CY7C129*DV18/CY7C130*DV25
 CY7C130*BV18/CY7C130*BV25/CY7C132*BV25
 CY7C131*BV18 / CY7C132*BV18/CY7C139*BV18
 CY7C191*BV18/CY7C141*AV18 / CY7C142*AV18/
 CY7C151*V18 /CY7C152*V18

Errata Revision: *C

May 02, 2007

RAM9 QDR-II/DDR-II/QDR-II/DDR-II Errata

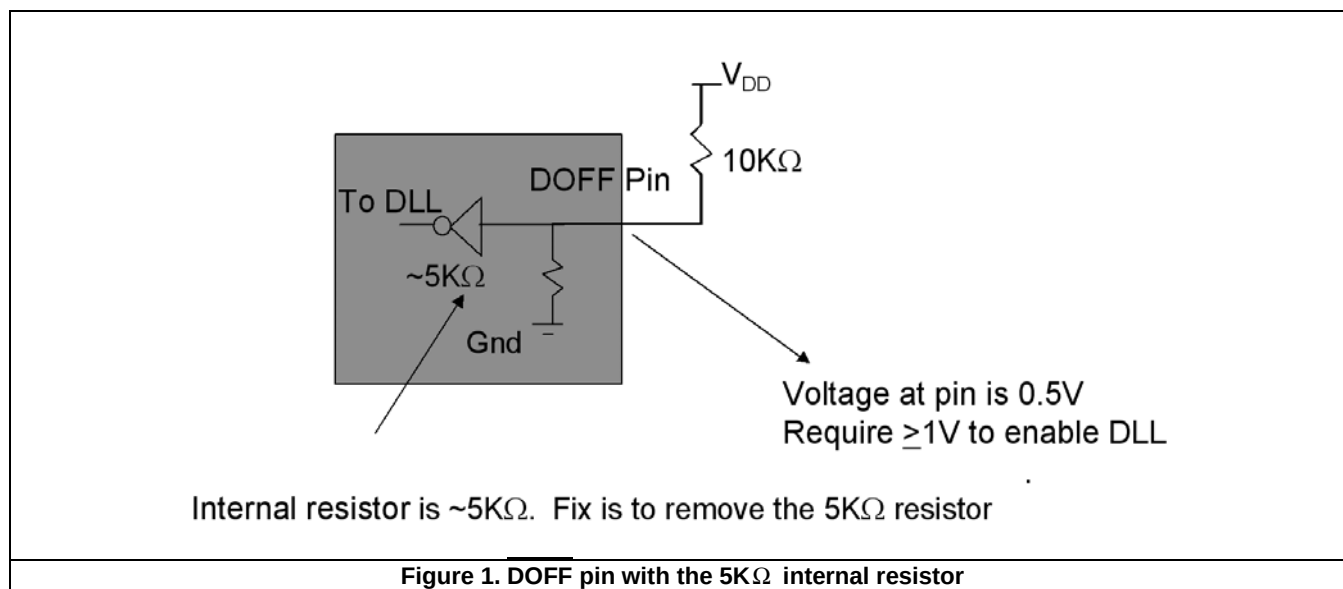
This issue involves the DLL not turning ON properly if a large resistor is used (eg:-10K Ω) as an external pullup resistor to enable the DLL. If a 10K Ω or higher pullup resistor is used externally, the voltage on DOFF is not high enough to enable the DLL.

Figure 1 shows the DOFF pin circuit with an internal 5K Ω internal resistor. The fix planned is to disable the internal 5K Ω leaker.

Fix involved removing the internal pull-down resistor on the $\overline{\text{DOFF}}$ pin. The fix has been implemented on the new revision and is now available. The new revision is an increment of the existing revision. The following table lists the devices affected, current revision and the new revision after the fix.

Figure 2 shows the proposed workaround and the fix planned.

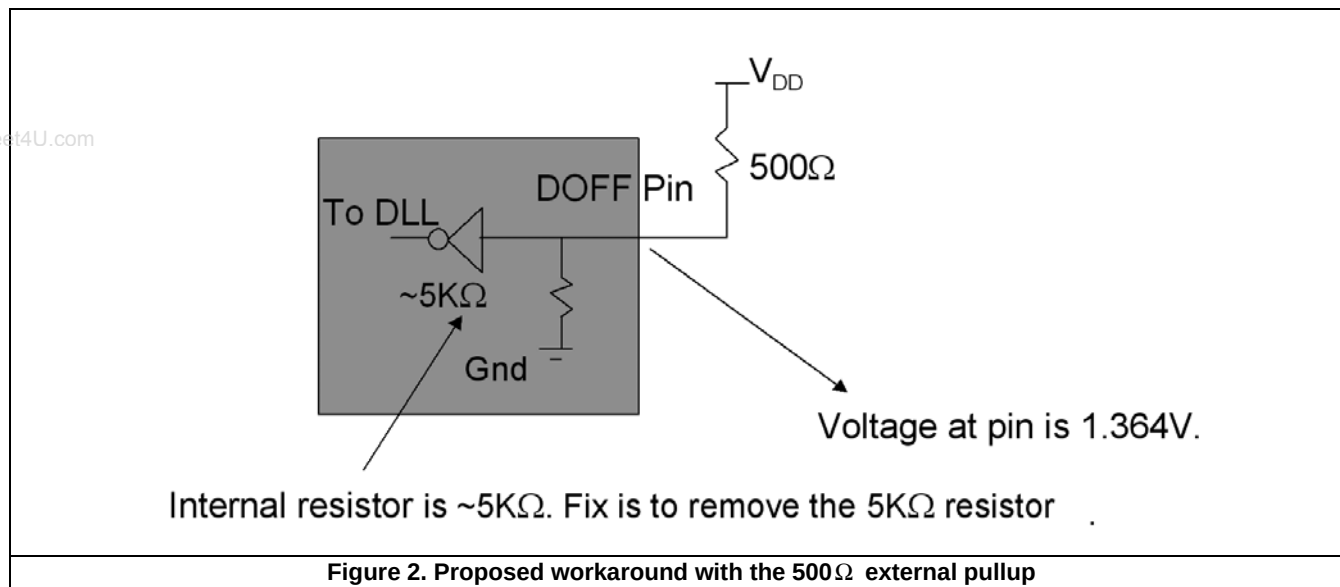
The workaround is to have a low value of external pullup resistor for the $\overline{\text{DOFF}}$ pin (recommended value is $\leq 500\Omega$). When $\overline{\text{DOFF}}$ pins from multiple $\overline{\text{QDR}}$ devices are connected through the same pull-up resistors on the board, it is recommended that this $\overline{\text{DOFF}}$ pin be directly connected to V_{DD} due to the lower effective resistance since the "leakers" are in parallel.

Figure 3. Output Register Reset Circuit

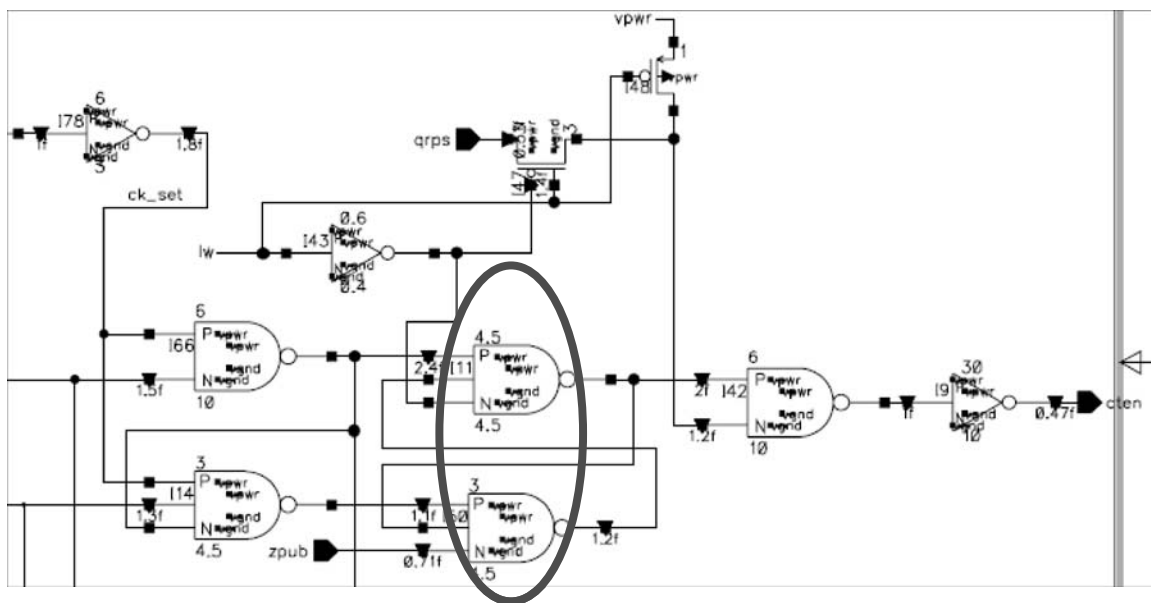
Figure 3 shows the output register Reset circuit with an SR Latch circled. This latch has two inputs with one of them coming from some logic affected by the clock and RPS#(QDR) or WE# and LD#(DDR). The issue happens when clocks are glitching/toggling with controls floating. This will cause the SR latch to be taken into an unidentified state. The SR Latch will need to be reset by a dummy read operation if this happens.

This is viable only if the customer has the trigger conditions met during reset or initialization of the memory controller after power up. In order for the workaround to perform properly, Cypress recommends the insertion of a minimum of 16 “dummy” READ operations to every SRAM device on the board prior to writing any meaningful data into the SRAM. After this one “dummy” READ operation, the device will perform properly. “Dummy” READ is defined as a read operation to the device that is not meant to retrieve required data. The “dummy” READ can be to any address location in the SRAM. Refer to Figure 4 for the dummy read implementation.

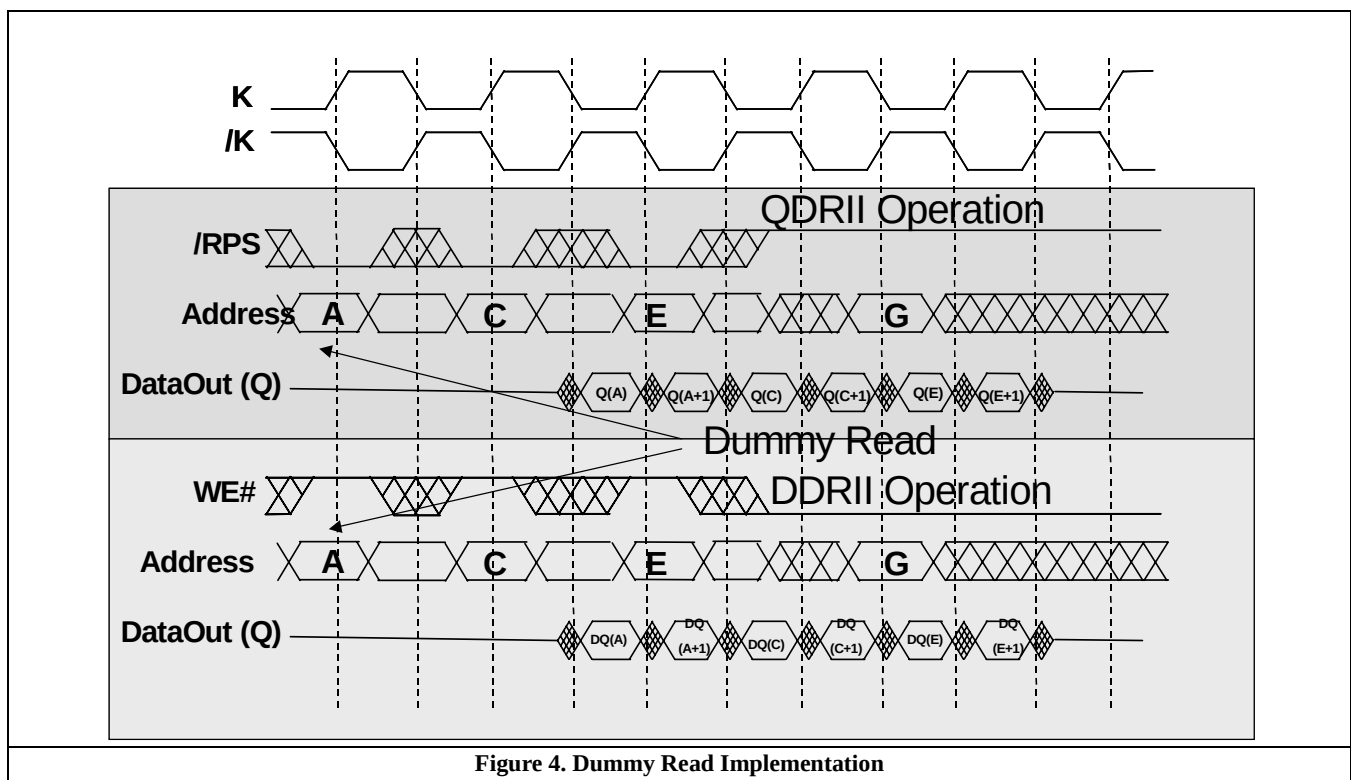
In systems where multiple SRAMs with multiple RPS# lines are used, a dummy read operation will have to be performed on every SRAM on the board. Below is an example sequence of events that can be performed before valid access can be performed on the SRAM.

- 1) Initialize the Memory Controller
- 2) Assert RPS# Low for each of the memory devices

- 1) For the 72M / 36M / 18M x9 devices drive address pin A2 / A10 / A3 low respectively and perform dummy read.
- 2) For the 72M / 36M / 18M x9 devices drive address pin A2 / A10 / A3 high respectively and perform dummy read.
